Los Alamos National Laboratory

SUBJECT: RESPONSE TO RSI FOR THE RFI REPORT AND CMS PLAN FOR PRS 16-021(C)

RESPONSE TO RSI
FOR THE RFI REPORT AND CMS PLAN FOR
TA-16, PRS 16-021(c)

Figure B-4.0-1. Topography, springs, seeps, National Wetlands Inventory, and LANL-defined wetland at TA-16.

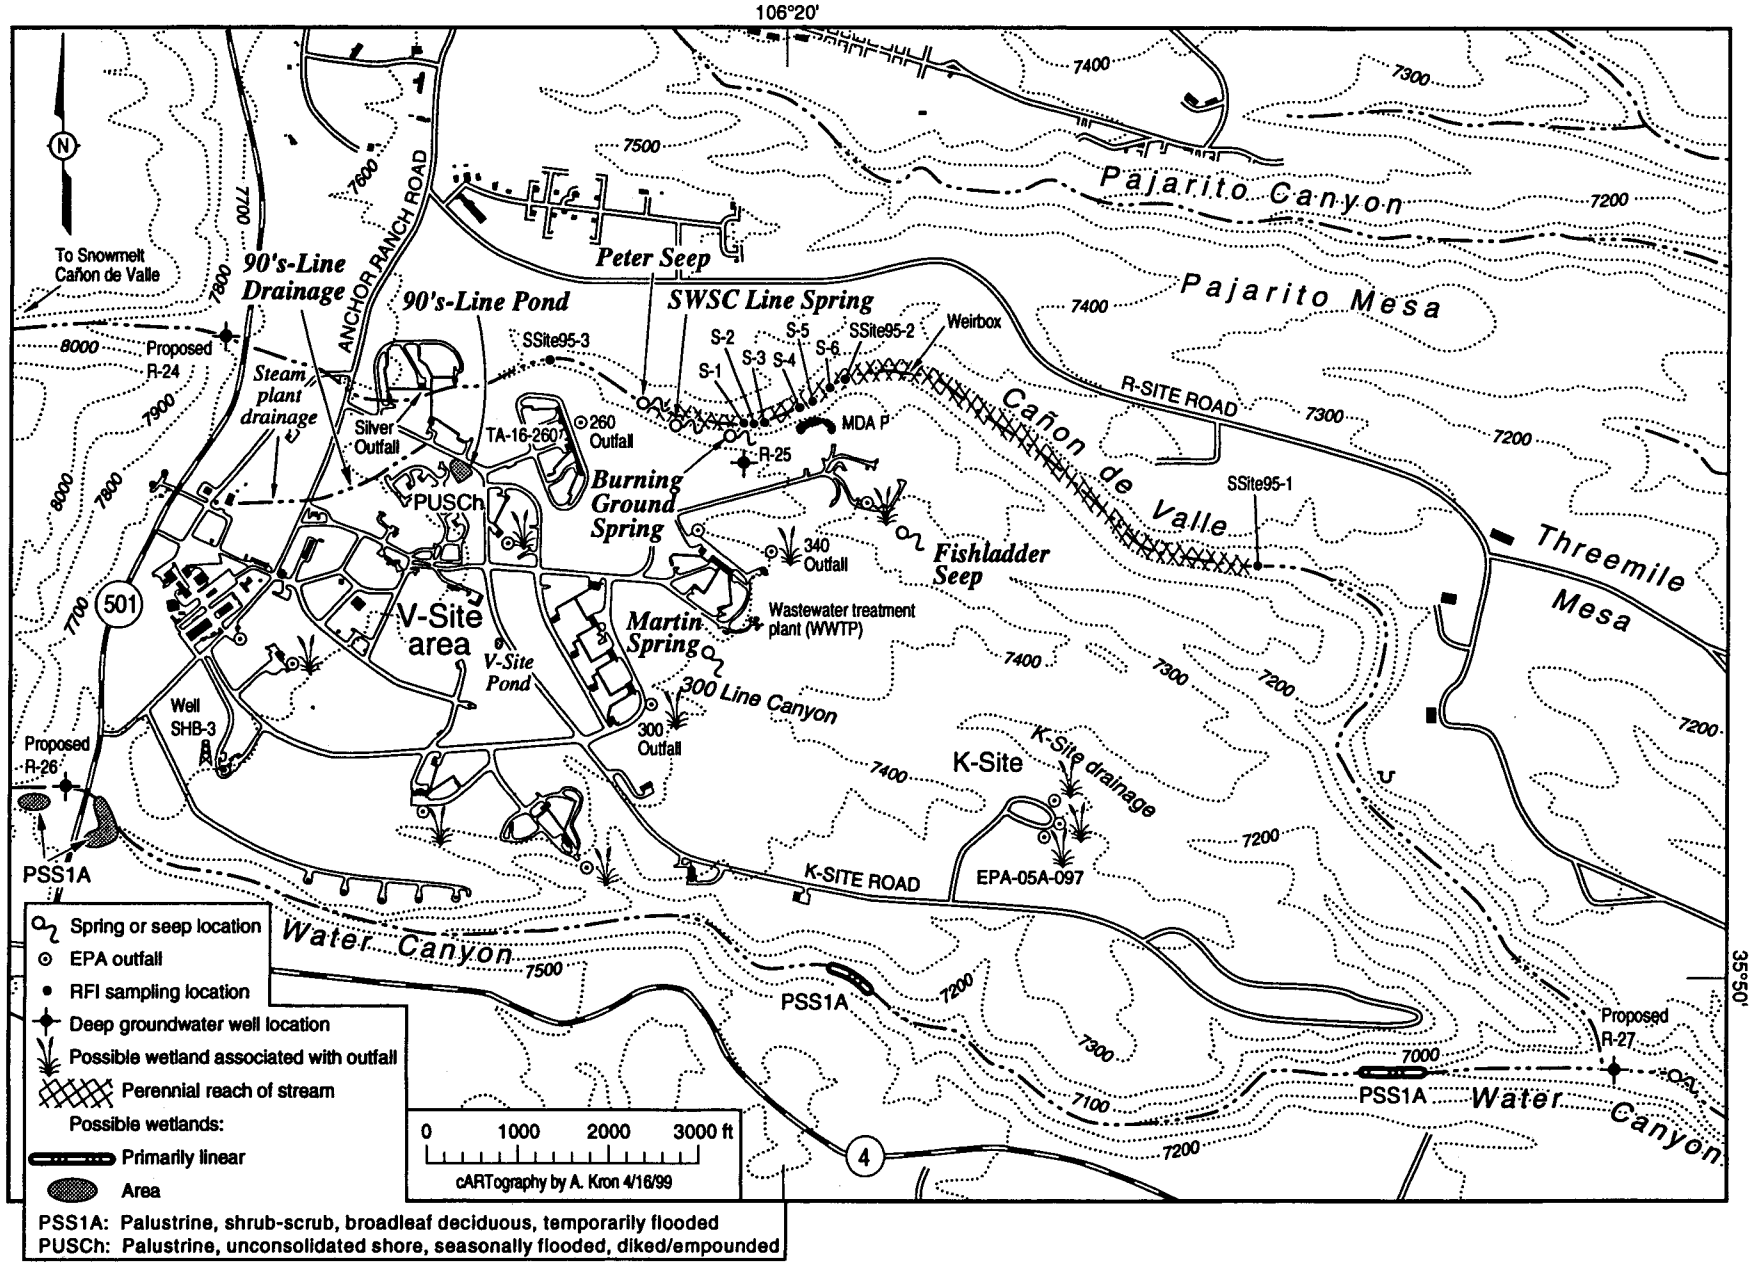
7. Appendix B: A location map of all the cited springs should be included.

Per the discussion between LANL representatives and HRMB personnel on April 12, 1999, LANL is including an additional figure (see Attachment II) showing the TA-16 water sampling localities that are shown in the Tables B-4.1-x in Appendix B, which were not included in Figure B-4.0-1. Background spring locations are available as Plate I of Blake et al. (Blake 1995, 49931) .
